**Final  
Phase II Environmental  
Baseline Survey**

of  
**Naval Weapons Industrial Reserve Plant  
Bethpage, New York**

**Revision 1, May 2002**

Subj: PHASE II ENVIRONMENTAL BASELINE SURVEY (REVISION I) FOR THE  
FORMER NAVAL WEAPONS INDUSTRIAL RESERVE PLANT (NWIRP)  
BETHPAGE, NEW YORK

DRAWN BY J. LAMEY		DATE 5/24/02		 Tetra Tech NUS, Inc.	CONTRACT NUMBER N7576		OWNER NO. —		
CHECKED BY —		DATE —			APPROVED BY —		DATE —		
COST/SCHEDULE-AREA —		DATE —			APPROVED BY —		DATE —		
SCALE AS NOTED		SITE LOCATION MAP PHASE II EBS NWIRP BETHPAGE, NEW YORK				DRAWING NO. FIGURE 1-1		REV 0

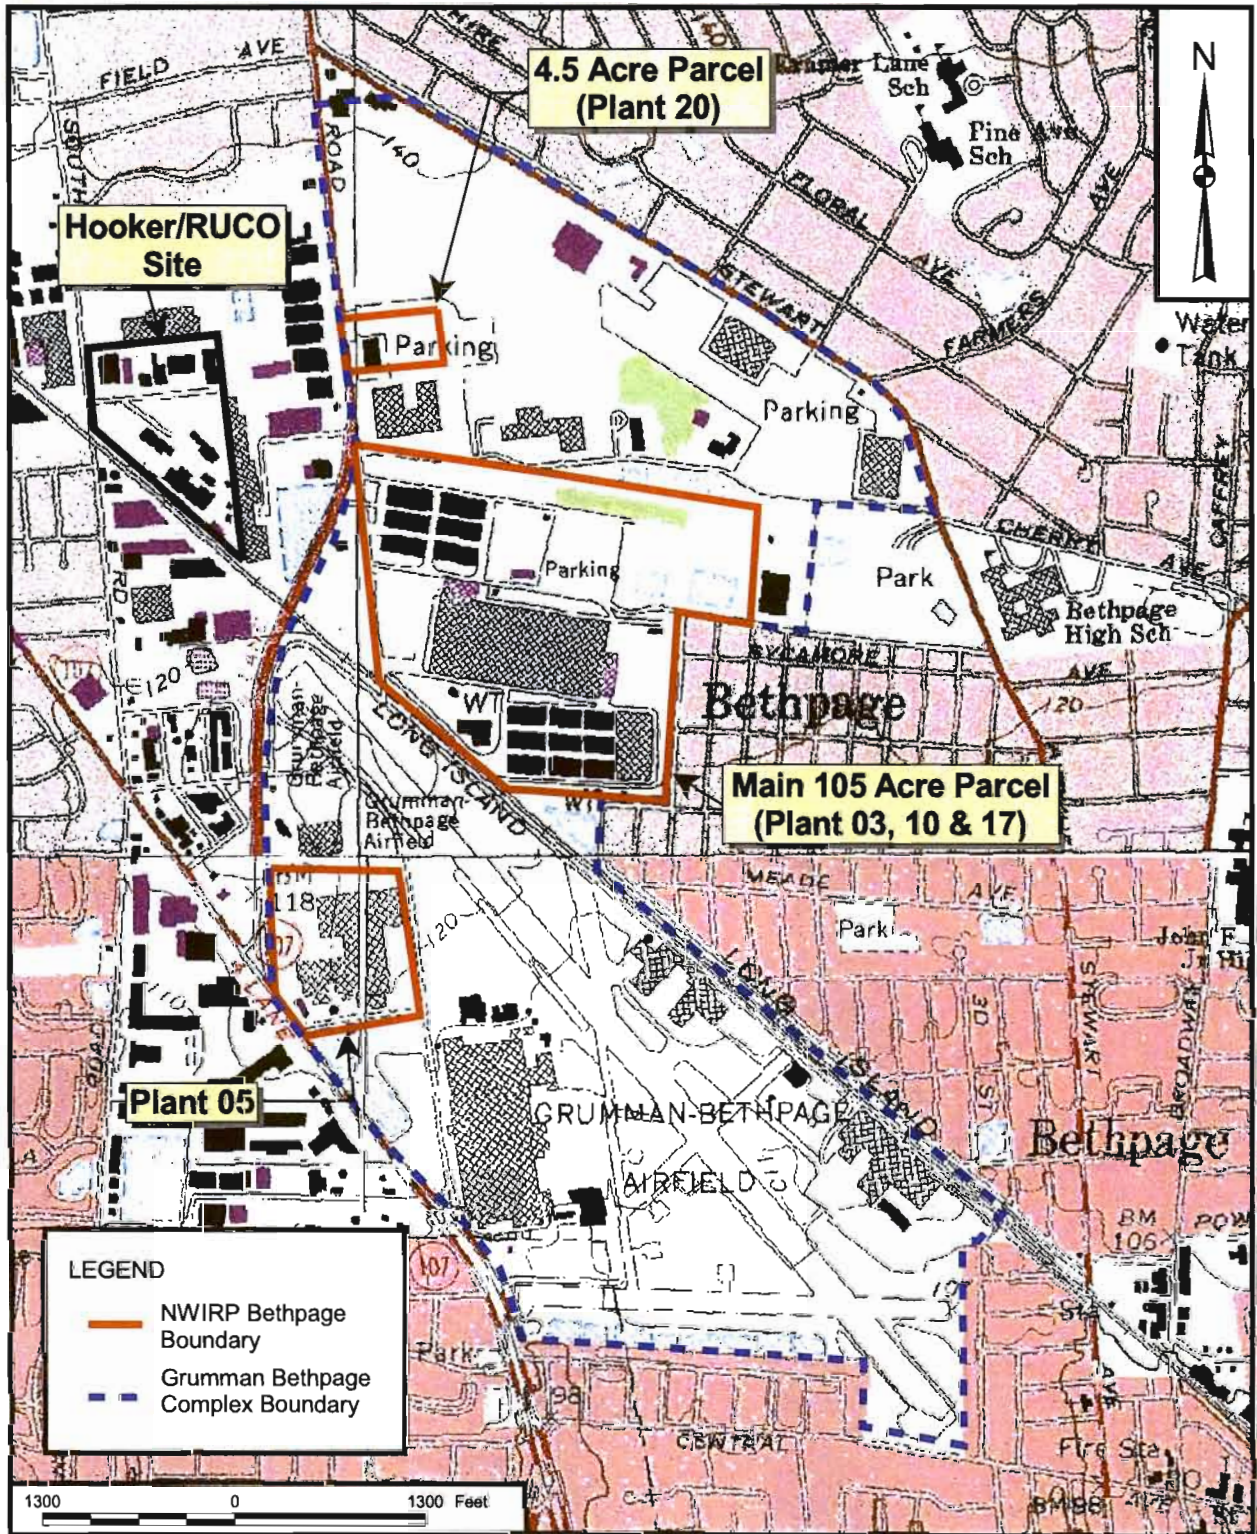
Comment 1: Figure 1.1 incorrectly shows the location of the OXY Hooker RUCO Facility. The Hooker facility is the next triangular parcel to the southeast.

Response: Figure 1-1 will be modified as indicated.

**Figure 6-1**

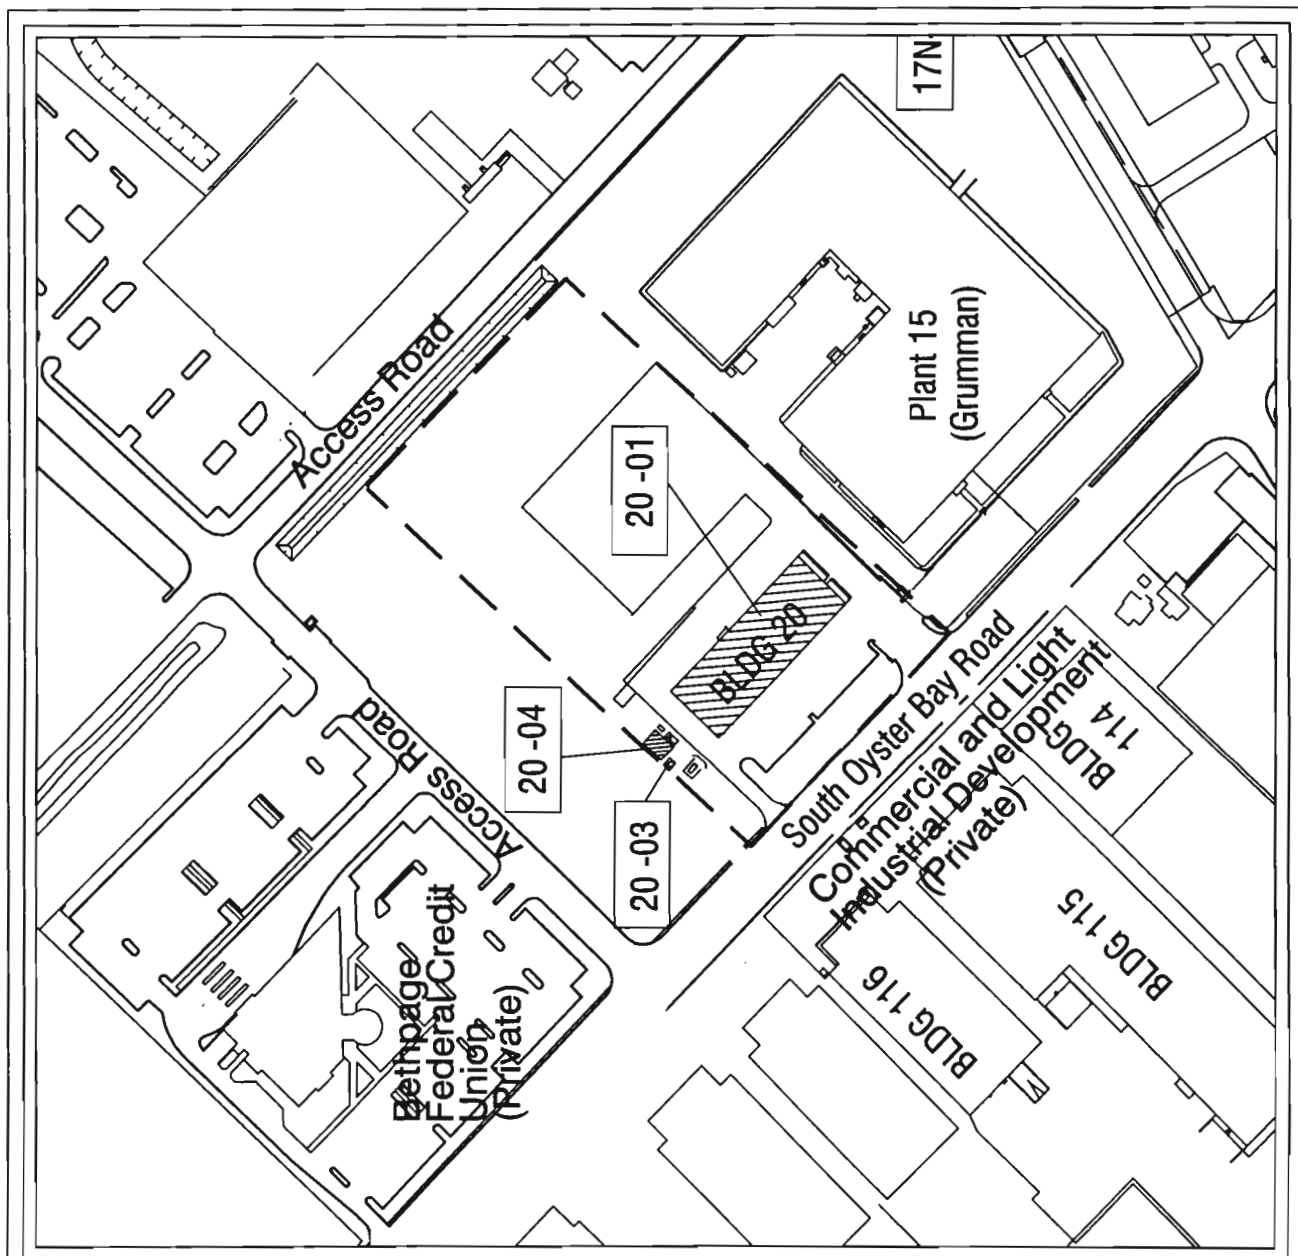
Comment 58: Page 6-1, Building 20-01: AOCs 1 through 6 are missing from Figure 6-1.

AOCs 1 through 5 are located inside Building 20-01. The exact location of each of AOCs 1 through 5 on a floor plan for Building 20-01 is shown in Figure 5, "Transportation Garage Building - Interior", in the *Phase I Environmental Site Assessment for the Plant 20 Transportation Maintenance Building*, dated February 1997 and prepared by Radian International for Northrop Grumman. Figure 6-1 will be revised to indicate that AOCs 1 through 5 for Plant 20 lie within the hatched area corresponding to the interior of Building 20-01.

AOC 6 constitutes the removed or abandoned USTs at Building 20-01, including Tanks 20-01-04, Tank 20-01-09, and Tank 20-02-01. Figure 6, "Current and Former Tanks - Plant 20" shows the locations of these tanks plus other tanks determined by Northrop Grumman to not require environmental sampling. These latter tanks were active and in compliance as of Northrop Grumman's Phase I ESA.
